STERLING RANCH - VOLLMER ROAD

STREET IMPROVEMENT PLANS

FEBRUARY 2018

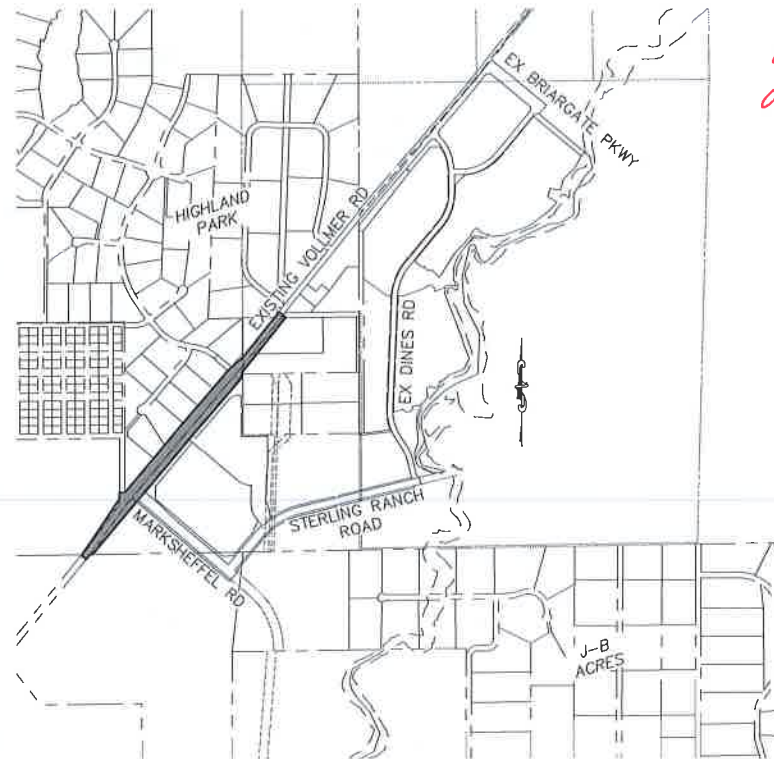
provide cross-sections
